Urgent Field Safety Notice

Potential for Suspension of Dynamic Sensing Algorithm

Aurora EV-ICD™ (DVEA3E4) UDI: 00763000368463, Clinical EV-ICD (DVEX3E4) <00763000217891

Medtronic Reference: FA1511

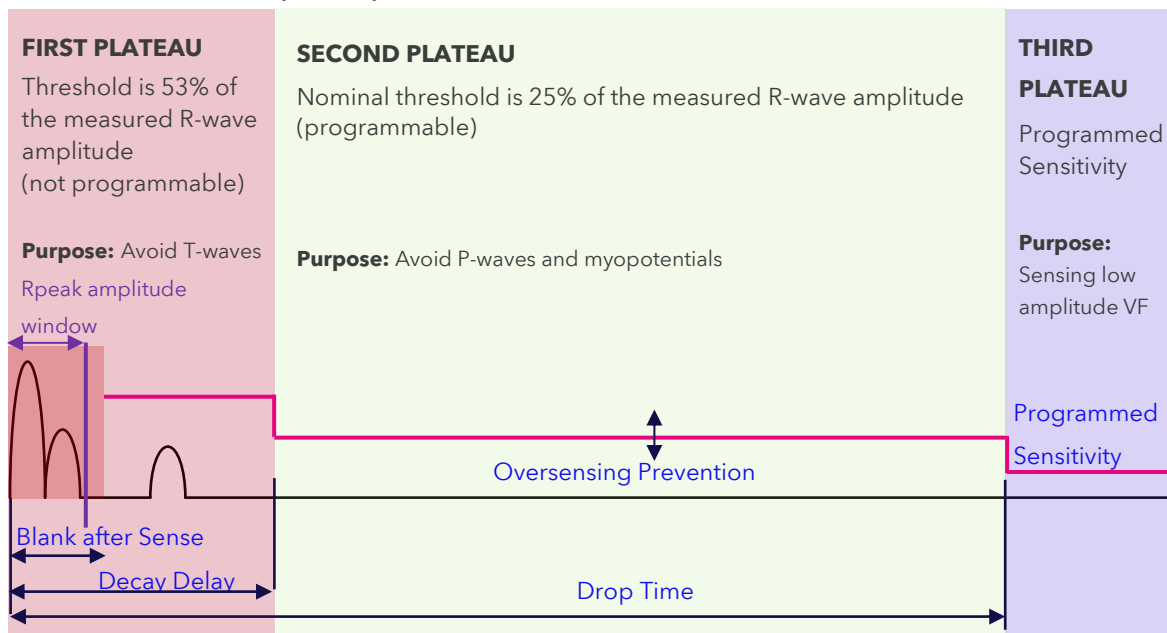
The dynamic sensing algorithm may become suspended at the first plateau if the following sequence of events occurs:

1. Charge-end occurs within 128.75ms of the prior sensed beat, thus interrupting the in-progress R-wave measurement-
suspension of the dynamic sensing algorithm occurs and the sensitivity plateau becomes static at 53%.
2. The sensitivity plateau will remain at 53% until a subsequent **R-wave amplitude exceeds this value.** In the case of a significant drop in R-wave amplitudes, delay in HV therapy delivery can occur.

Medtronic has implemented manufacturing changes, and devices manufactured with this update are not susceptible to this delay. In previously distributed devices, a device interrogation with the CareLink™ SmartSync™ Aurora EV-ICD™ application (D00U025) on CareLink SmartSync Device Managers will resolve the potential for this behavior (see Appendix B).
